# **Nuclear Regulatory Commission's Request for Additional Information on the Draft Waste Incidental to Reprocessing Evaluation for Waste Management Area C at the Hanford Site**

Chris McKenney, David Esh, and Hans Arlt

Thursday, May 30, 6:00 – 8:00 p.m.  
Richland, WA

Figure C-1 from the WMA-C PA

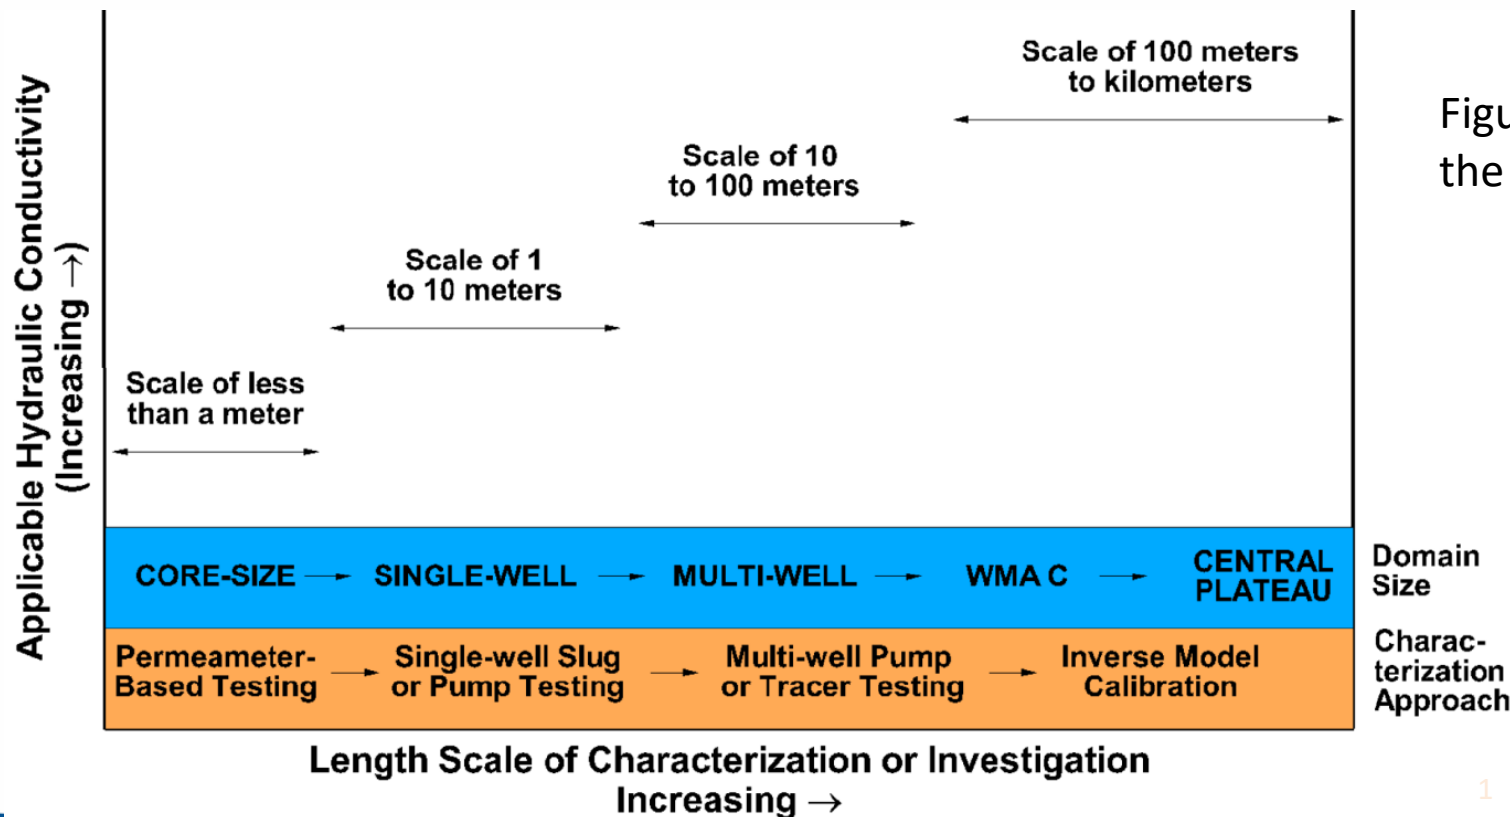
**RAI 2-10** Comment: Additional information is needed to support a technical basis for using a relatively high hydraulic conductivity value for the unconfined aquifer.

- The WMA C PA document shows that the saturated zone Darcy flux is an important parameter.

Figure C-6 from the WMA-C PA

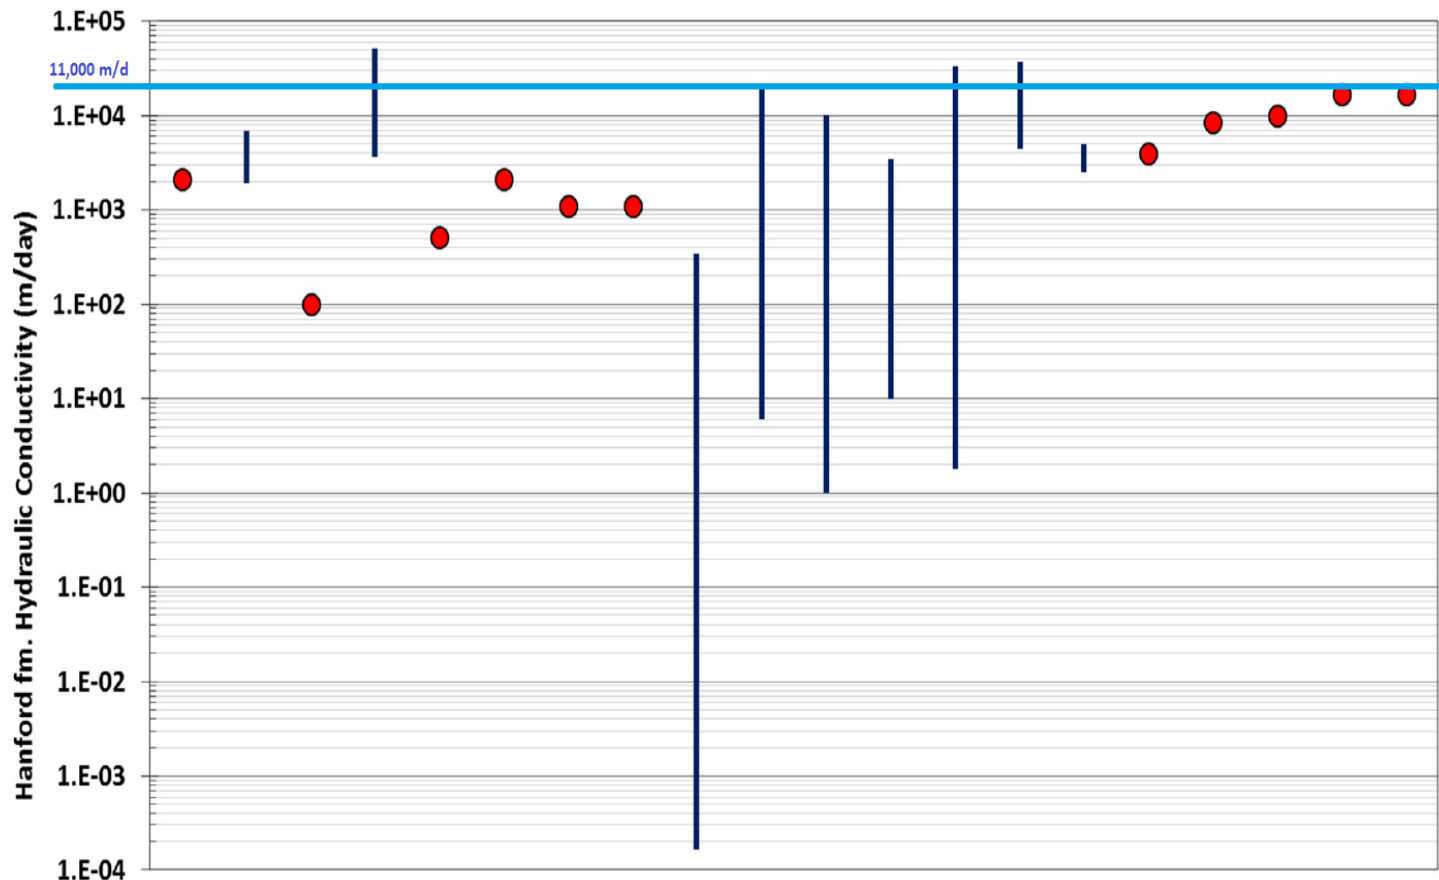
## RAI 2-10 Comment continued

- Previous sources provided a lower range of hydraulic conductivity values compared to the current average WMA-C PA value of 11,000 m/d.

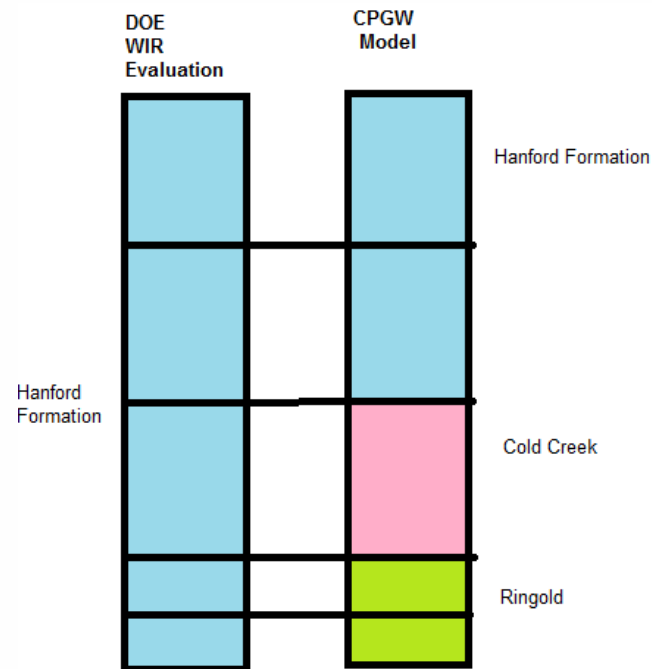
**RAI 2-13** Comment: Differences in the conceptual hydrogeological models near WMA C between the regional Central Plateau Groundwater (CPGW) model and the WMA C STOMP model are considerable and some of the techniques for abstracting information and data from the CPGW model to the STOMP model require additional information.

- Differences in the hydrogeological units between the STOMP model in the WIR Evaluation and the CPGW model (see example figure).
